Diablo Canyon
Independent
Safety Committee

Public Meeting
October 22 and 23, 2025

Diablo Canyon Power Plant Regulatory Performance Update

Isostatic and Gravimetric Analysis

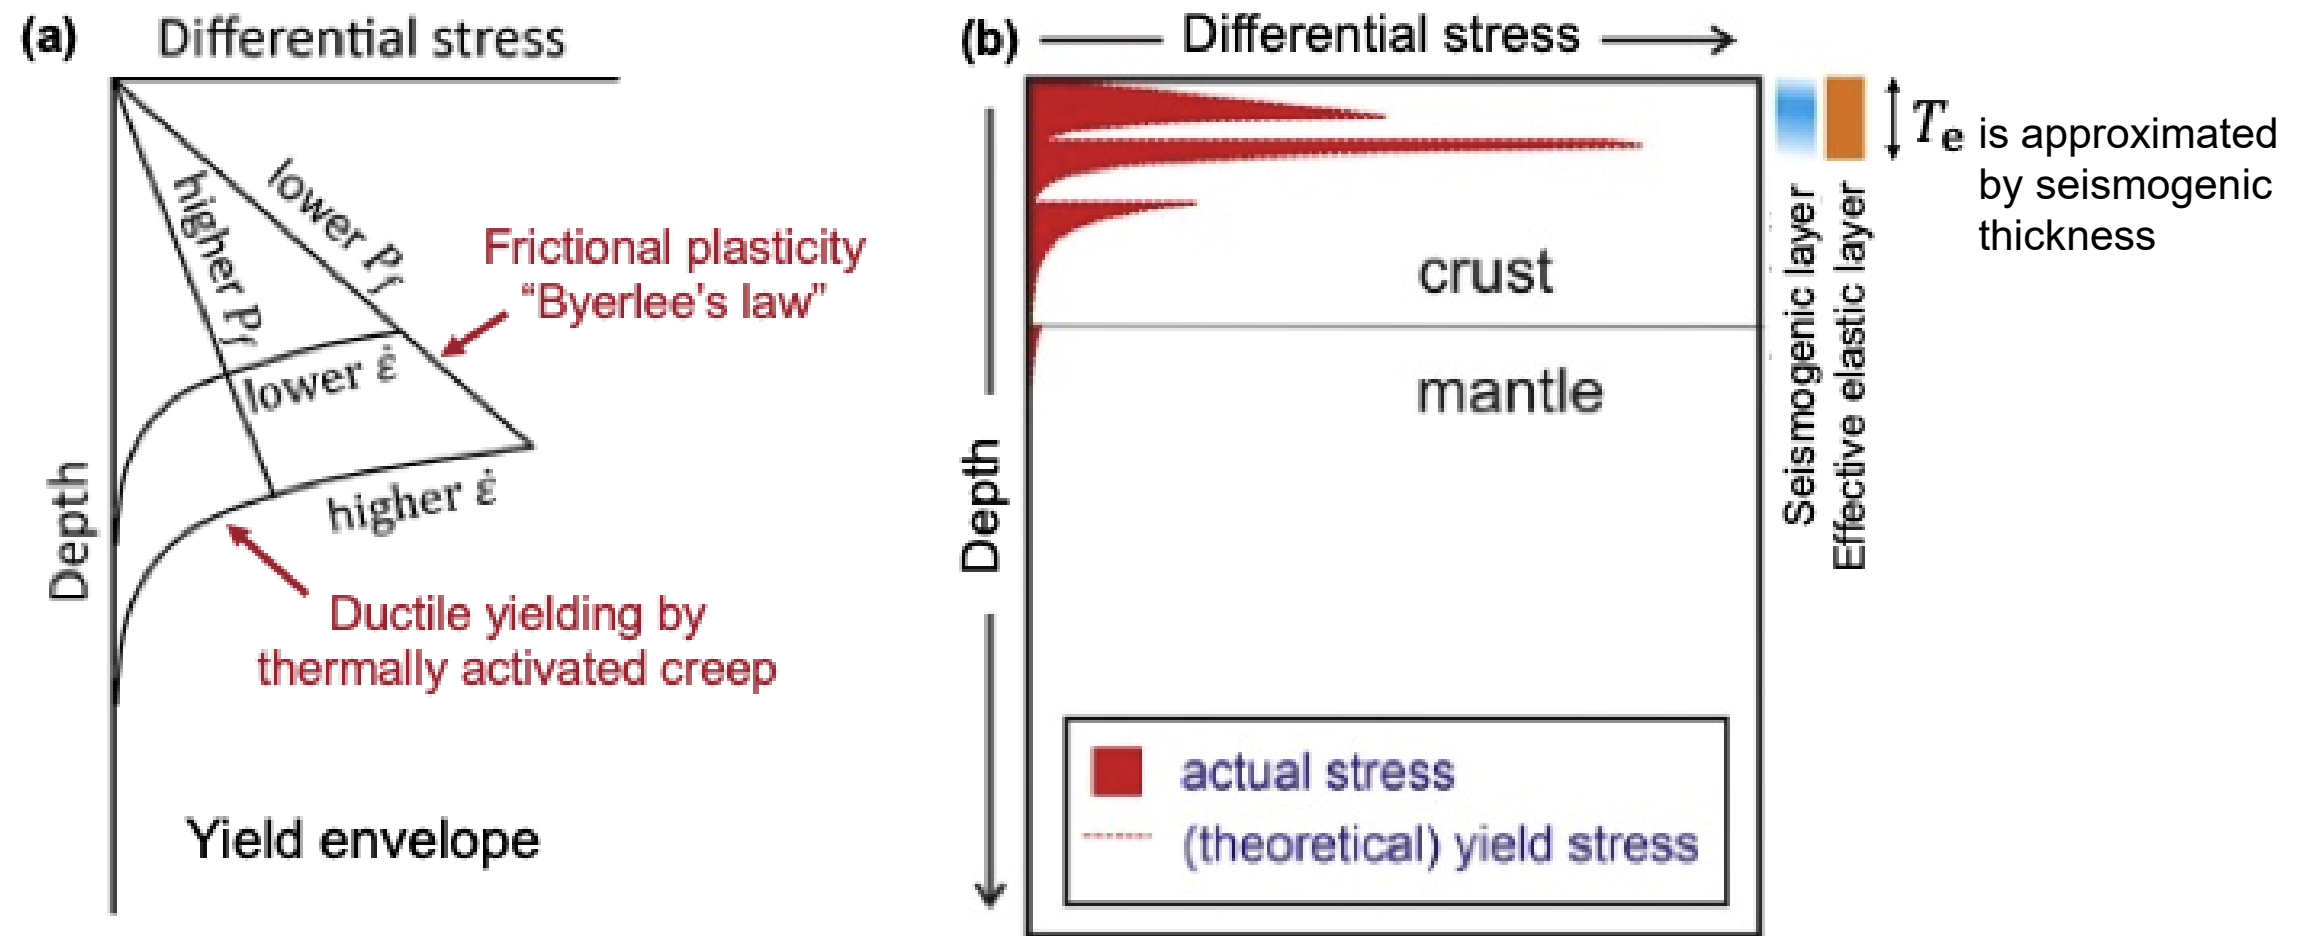
- Assumes Airy isostasy, where local topographic height is balanced by local Moho depth
- Implies crustal thickening rate is 6 times the uplift rate

SRT review: Airy isostasy cannot be applied to loads of as small as the Irish Hills

- Loads are supported by lithospheric rigidity (regional compensation), parameterized by an effective elastic thickness $T_e \approx$ seismogenic thickness ≈ 10 km
- Implies a bending wavelength of ~ 200 km
- Dimension of the Irish Hills is ~ 20 km is much less than 200 km
- But Airy isostasy requires the load dimension to be much greater than 200 km

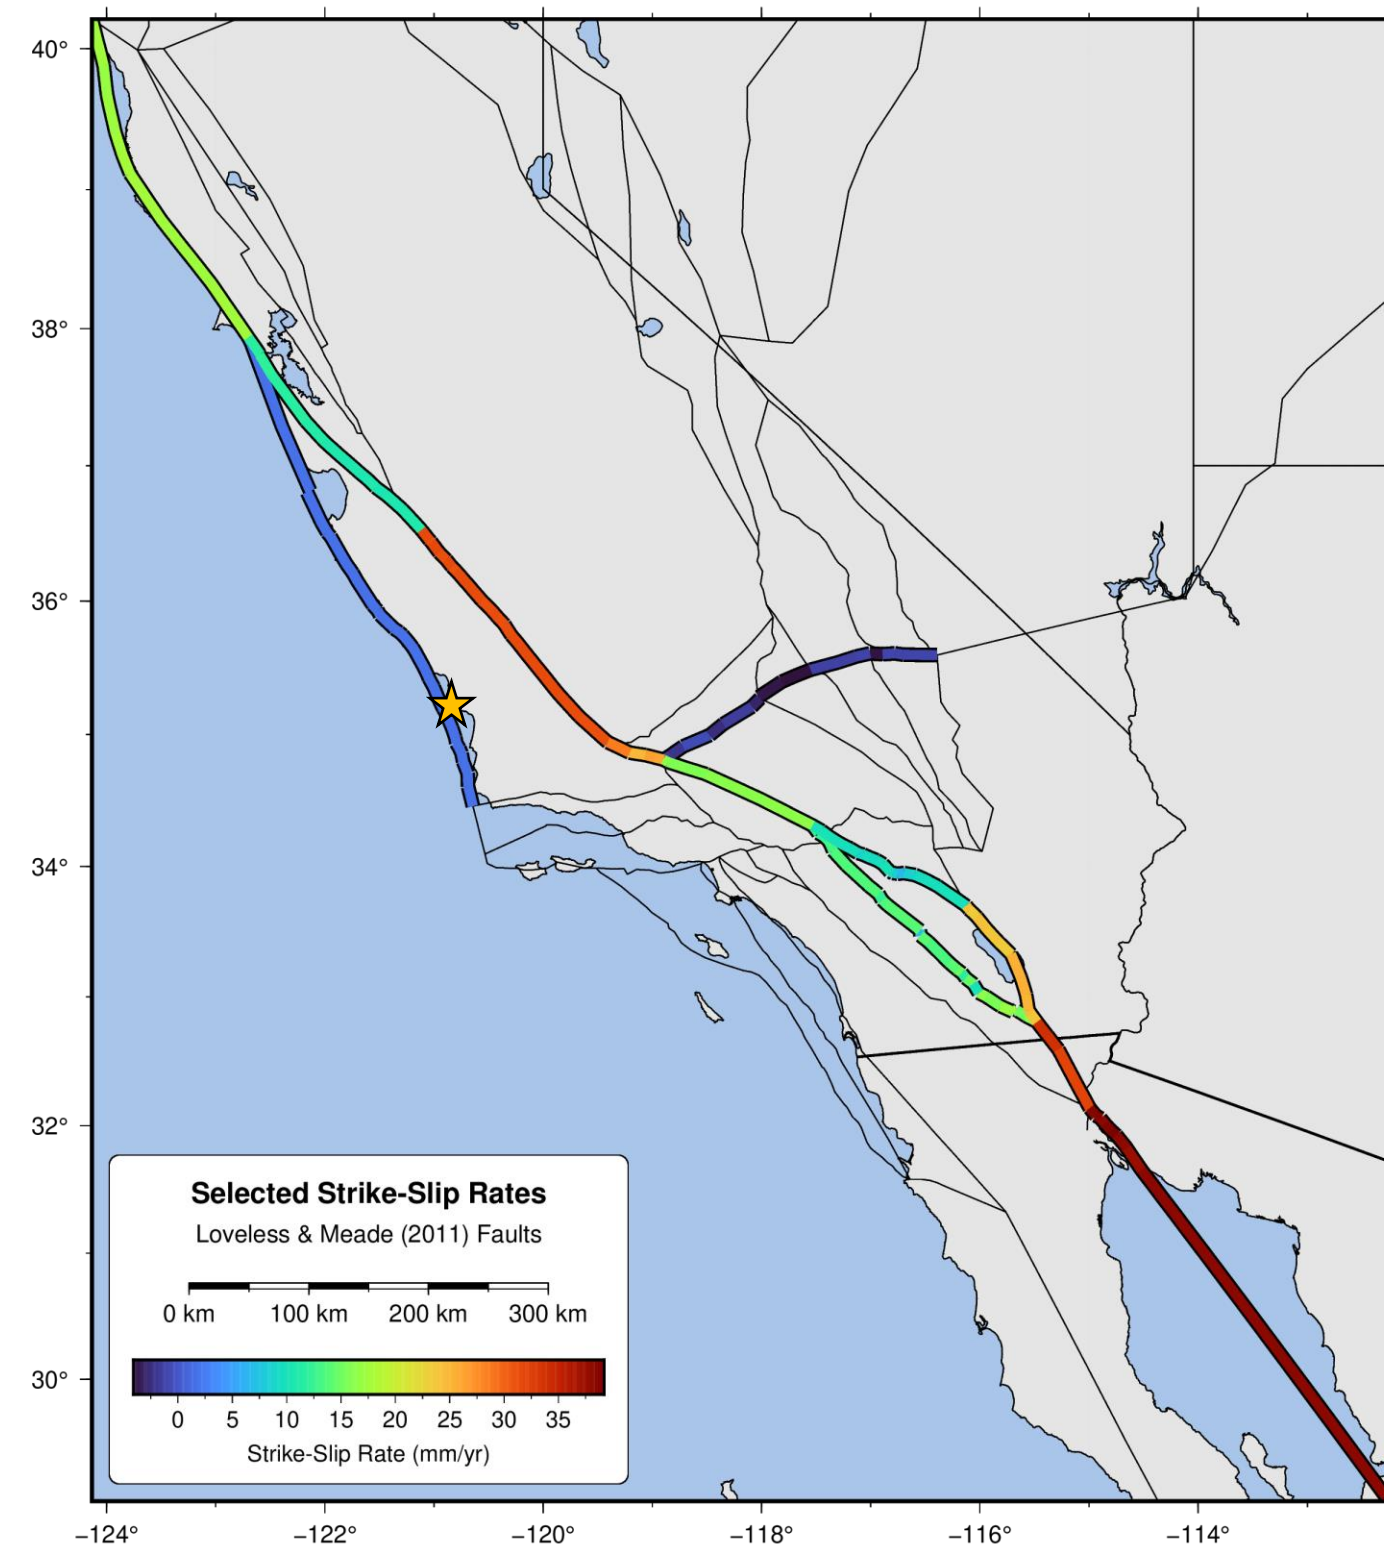
Bird objection: “Correction(s) for effects of distant faults. The SRT is quite right that this correction is appropriate, in principle. However, I will argue that the SRT did not perform this step correctly, and improperly reduced the magnitude of the shortening-rate signal by 50~75%.”

SRT: This correction is valid and **increased** the shortening rate across the Irish Hills.

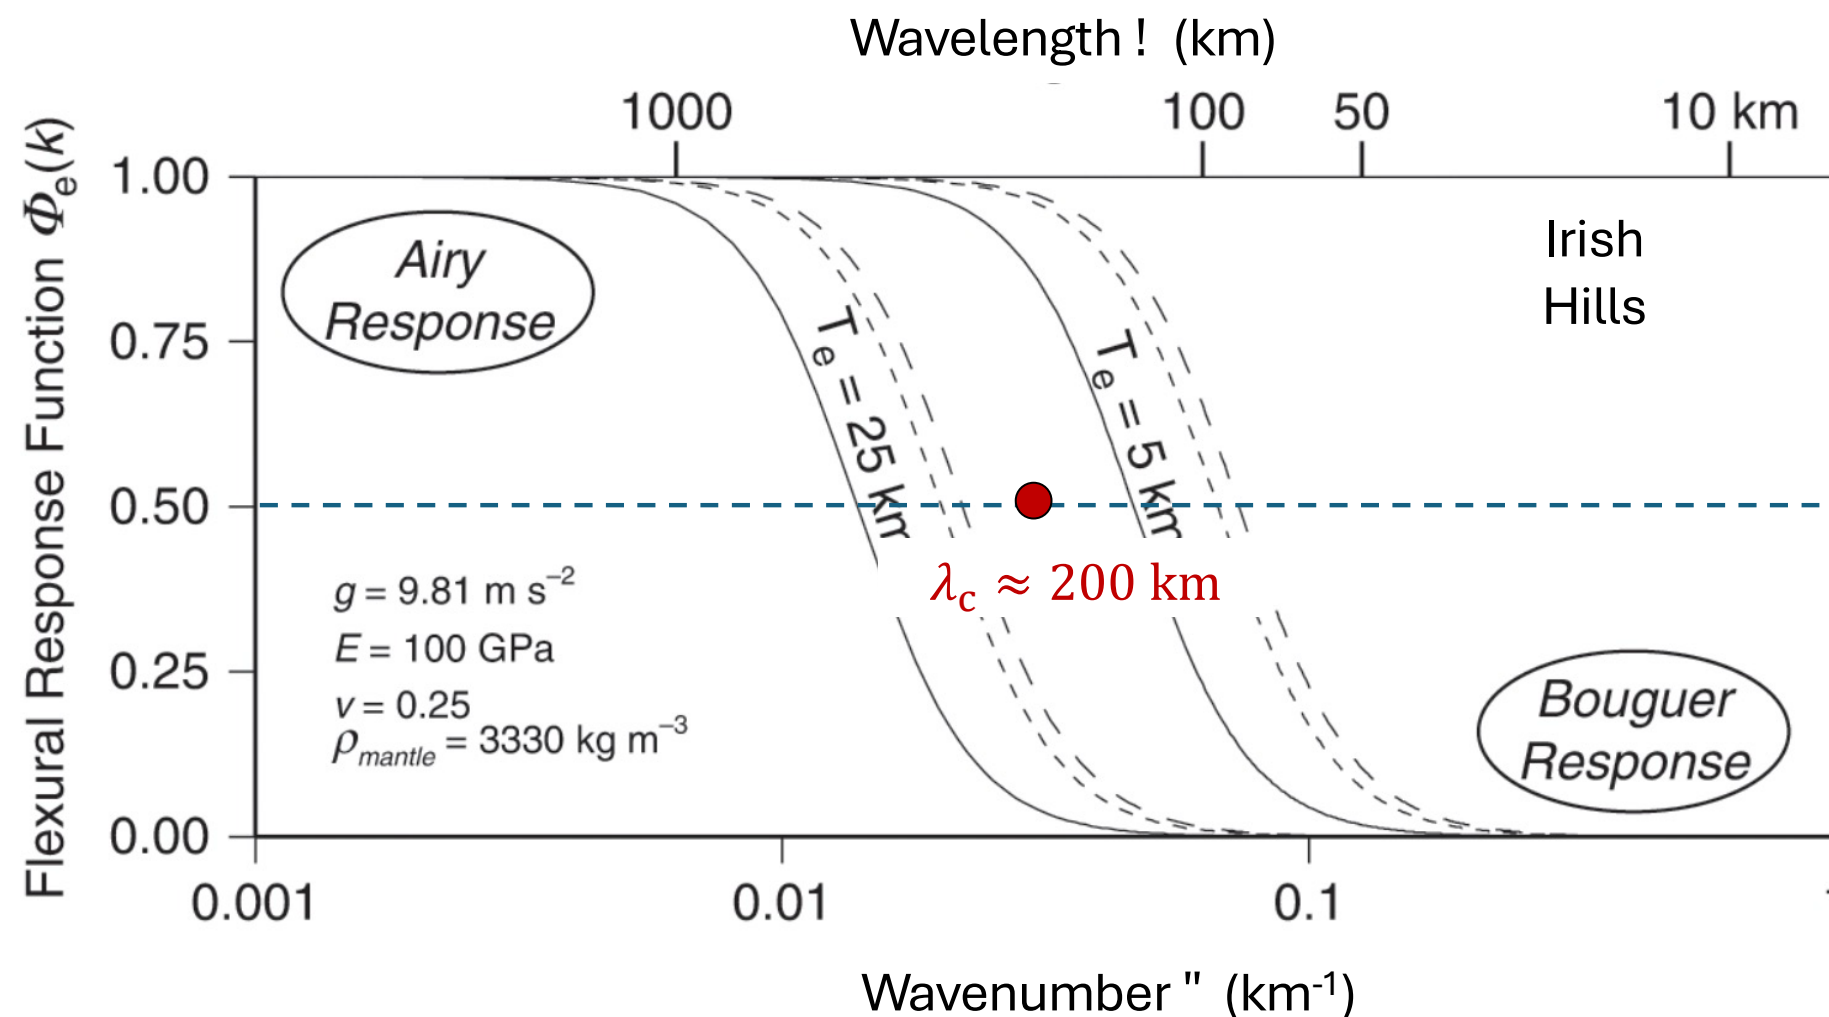
- a. PG&E (2015, 2024) underestimated the hazard to DCPD from thrust faulting under the Irish Hills because it made four false assumptions. Removing these assumptions increases the thrust-faulting potency rate by a large factor.

SRT finding: *Removing the four false assumptions in the development of a revised SSC would have little to no impact on the hazard estimates.*
